RE: PROPOSED RESIDENTIAL DEVELOPMENT - 17-19 MAUD STREET, NEWSTEAD
TRAFFIC ENGINEERING RESPONSE TO COUNCIL'S INFORMATION REQUEST

This traffic letter has been prepared in response to Brisbane City Council's (BCC) Information Request, dated 11 August 2026, for the proposed residential development located at 17-19 Maud Street, Newstead QLD 4006, formally described as Lot 67 & 68 on RP9348. The traffic engineering issues being addressed are presented below in *italics*.

Figure 2 Bicycle Parking Access - Ground Floor

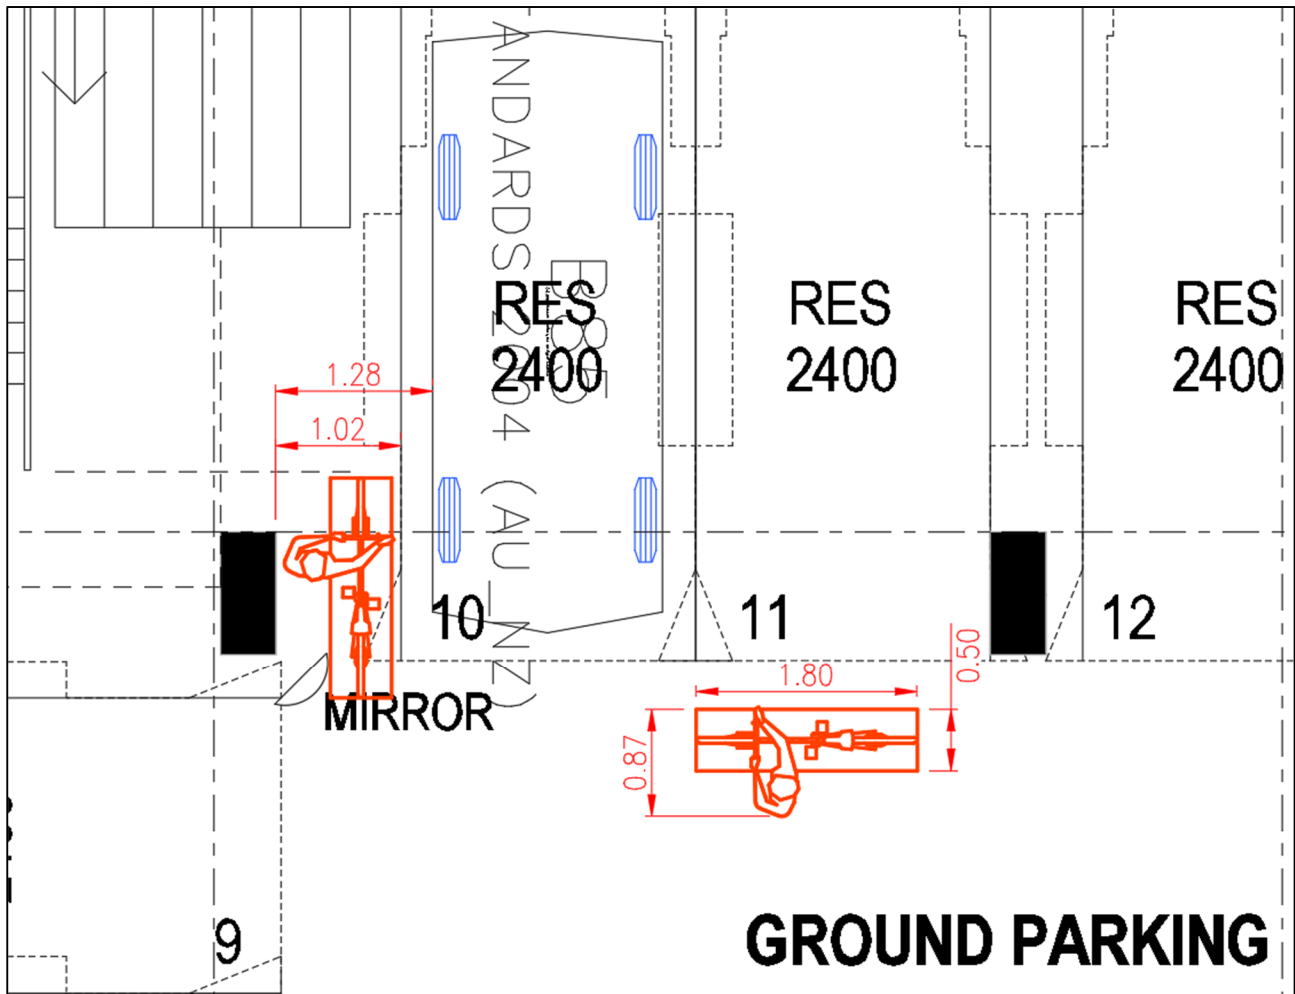
8. *The access aisle to the resident bicycle parking area adjacent to car space 10 on the ground floor is non-compliant. The width should be approximately 1.5m to ensure a person is able to walk through next to their bicycle and the plans indicate a width of 1m. Review the current design and consider deleting car space 10 to accommodate safe bike / walking rider access in accordance with AS2890.3. The car space may be suitable to remove altogether or change to a small parking space.*

As outlined in the submitted Traffic Report, it is acknowledged that the access width to the bicycle storage area in the south-western corner of the Ground Floor is below the typical AS2890.3 requirement of 1.5m. A performance outcome is sought for a reduced width of 1.02m. As illustrated in Figure 2 below, residents will still be able to comfortably gain access to the bicycle storage area when wheeling a 0.5m wide bicycle. The bicycle parking area will be easily accessible and will operate with very low turnover. The current arrangement is considered suitable for the proposed development in our view.

Figure 3 AS2890.1 Pedestrian Sight Triangle

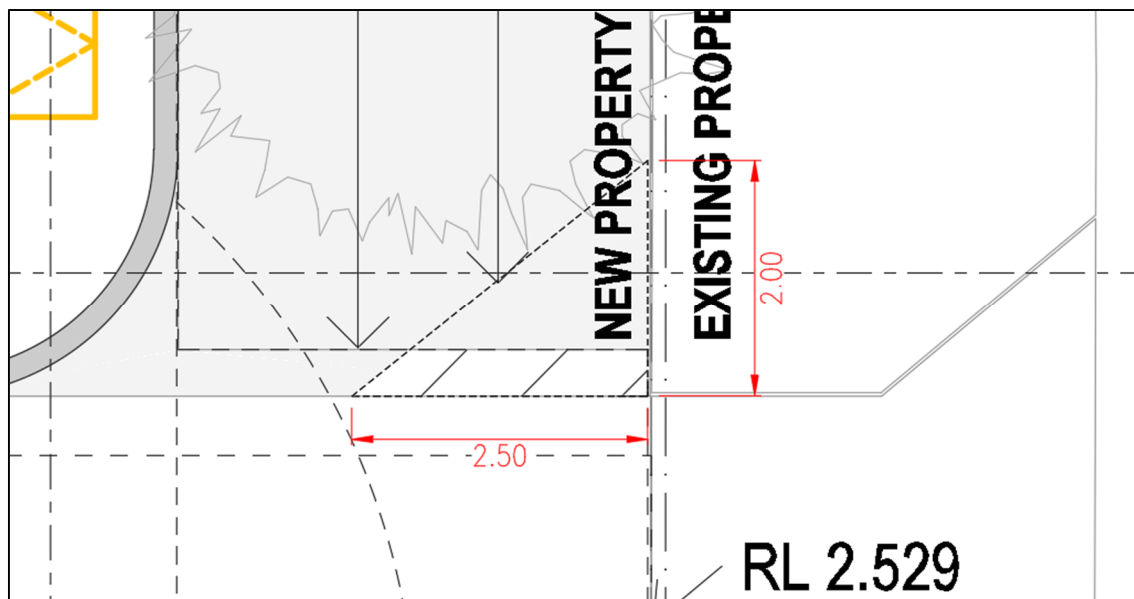
9. Provide amended plans with a pedestrian sightline splay, 2m x 2m, as per fig C of TAPS PSP, to the exit driveway.

As seen on the architectural plans enclosed within this letter and Figure 3 below. the Ground Floor layout already provides allowance for a 2.5m x 2.0m pedestrian sight triangle on the exit side of the crossover, generally in accordance with AS2890.1. We note this represents a more conservative envelope than the 2m x 2m sightline splay requested by Council and an industry accepted design outcome. Any landscaping in this triangle will be limited to low level only, up to a maximum height of 0.5m, and can be conditioned accordingly.

CORA BIKE RACK

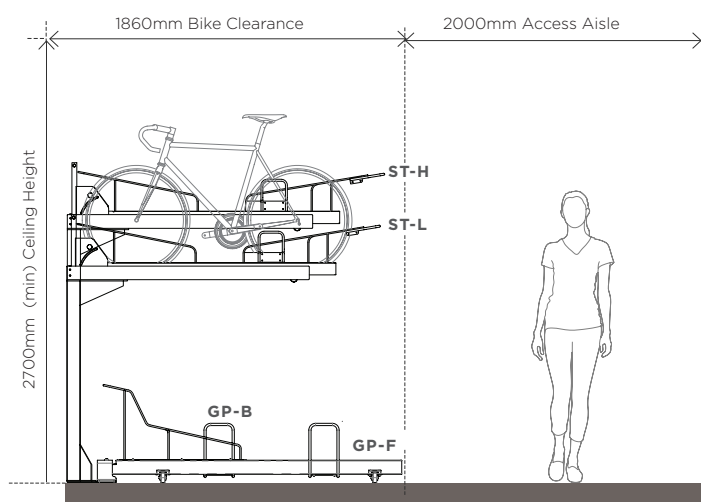
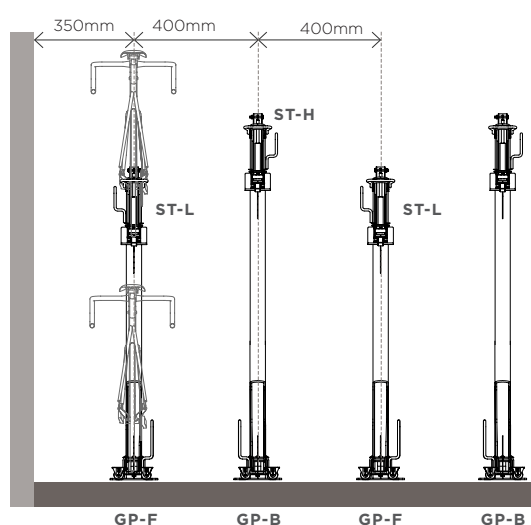
14. The proposed basement bike parking envelope widths do not appear to meet the minimum requirement of 500mm. The submitted TIA report advises that all resident bicycle parking spaces have been provided in the form of dynamic multi-tiered bicycle stackers. Further information is required for typical system utilised for the multi-tiered stackers.

- a. Provide details on the bicycle stackers to be utilised for the residential bicycle parking areas. For example, do the rack systems reduce widths by alternating heights of bicycles to comply with the relevant standards? Alternatively, the removal of some carparks to provide additional bicycle parking space could suffice, where appropriate.

A detailed specification sheet for dynamic multi-tiered bicycle parking facilities has been enclosed within this letter. In accordance with AS2890.3, dynamic bicycle parking devices (BPD's) can provide functional bicycle parking with a reduced effective bicycle spacing envelope width of 400mm where handlebars of adjacent parked bicycles are not in alignment and where cyclists can still create space to access and lock their bicycle.

The architectural plans provide spatial allowance for 1860mm x 400mm bicycle parking envelopes with a minimum access aisle width of 2000mm and minimum height clearance of 2700mm, consistent with the *Cora Bike Rack* specifications and generally in accordance with the requirements of AS2890.3. As such, no changes to the bicycle parking arrangements or removal of vehicle parking spaces are required.
